UNITED STATES PATENT AND TRADEMARK OFFICE

APPLICATION NO.	FILING DATE	FIRST NAMED INVENTOR	ATTORNEY DOCKET NO.	CONFIRMATION NO.
10/614,136	07/08/2003	Chin-Liang Lin	L9079.03103	5979

Office Action Summary	Application No.	Applicant(s)	
	10/614,136	LIN ET AL.	
	Examiner	Art Unit	
	Shumaya B. Ali	3743

DETAILED ACTION

Fig. 1

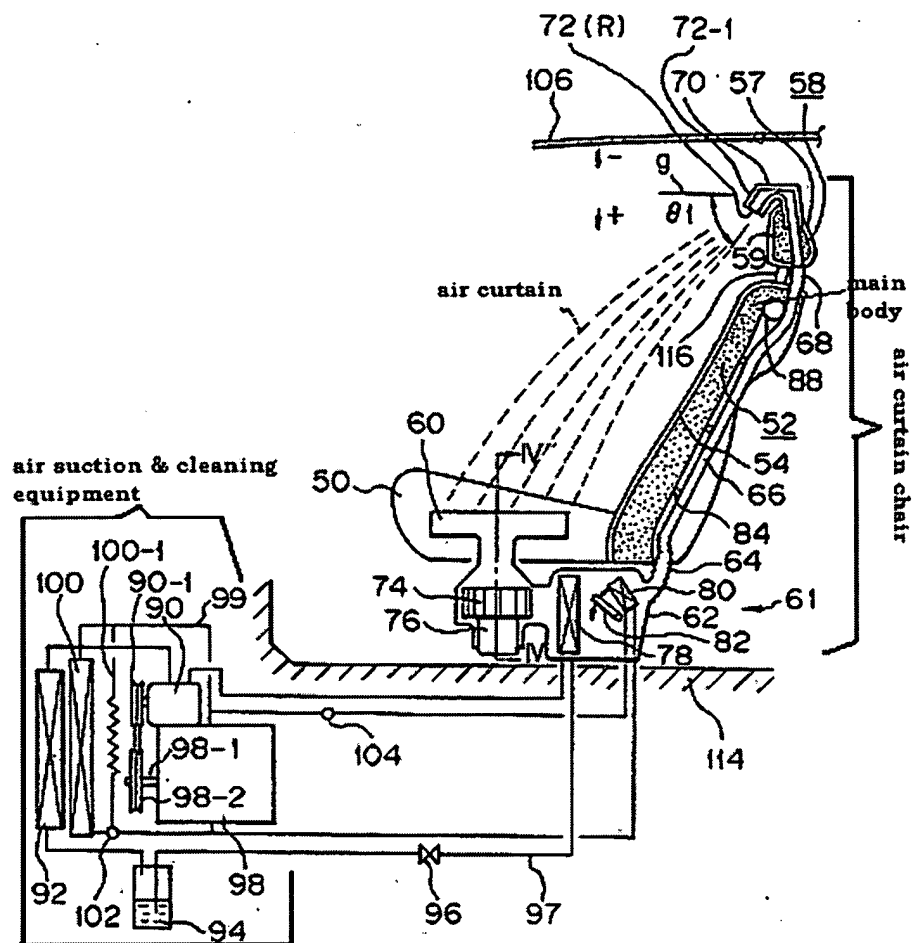
7. **As to claim 1**, Inoue et al. disclose a chair (car seat) with air-curtain shield (see Fig.1 and col.16 lines 65-68) comprising an air-curtain chair (see attached Fig.1) with a main-body (see attached labeled Fig.1) and at least one set of air-suction and cleaning equipment (see Fig.1 reference objects 90 and 92) which are connected to form an air filtration and circulation system to generate air-curtain shield and filtrate the air making it suitable for cyclic-use, and the said air-suction and cleaning equipment (see Fig.1 reference objects 90 and 92) has an air suction inlet (see attached Fig.41) and an air discharging outlet (see attached Fig.41) through which when the air-suction and cleaning equipment (see Fig.1 reference objects 90 and 92) is in operation, the air is sucked into the equipment for filtration and cleaning treatment, and then discharged from the air discharging outlet (see attached Fig.41); wherein the said main-body (see attached Fig.1) of the air-curtain chair comprises a seat surface (Fig.1 reference object 50), a seat back (Fig.1 reference object 52) and two hood-walls (see attached Fig.33); the said seat back extends from the

8. **As to claim 2**, Inoue et al. disclose an air outlet (see attached Fig.41) is located at the bottom of the said top-hood at the location corresponding to the air suction slot on the said seat surface (see Fig.1 reference objects 60, 72, col.16 lines 60-68, and col.17 lines 2-5).

9. **As to claim 3**, Inoue et al. disclose the opening of air outlet at the bottom of the top hood are air flow guide (see Fig.1 reference object 72) which can make the air flow stream a downward lamina flow, **however fig.1 does not disclose in vertical (downward) direction.** The embodiment 3, figures 32-35 teaches a plurality of outlet openings that are opened to a position located rearwardly of and slightly above a headrest. Furthermore, a cover portion is provided that overhangs the upper part of a sitting person. The overhang portion is merely recessed to provide an outer vertical guide plate for guiding the flow from the discharge outlet (see col.17 line 23-30). Therefore, a plurality of outlet opening with an outer vertical guide plate overhang is capable of producing an air curtain shield in a downward vertical direction (the downward vertical lamina flow is clearly depicted by the small arrows in figure 35). Therefore, it would have been obvious to one of ordinary skills in the art at the time the invention was made to modify the invention of embodiment 1 in view of embodiment 3 in order to provide the air-curtain chair with a plurality of outlet opening with an outer vertical guide plate overhang for the purposes of directing air-curtain shield in a vertical downward direction.

12. **As to claim 9**, applicant considers medical level air-suction and cleaning equipment comprising an air suction inlet (see attached Fig.41), an air discharging outlet (see attached Fig.41) and an air filtration-sterilization unit (compressor and condenser) (see attached Fig.1 reference objects 90 and 92). Therefore, it would have been obvious to one of ordinary skill in the art to consider the air suction and cleaning equipment as disclosed by Inoue et al. to be equipment of medical level.
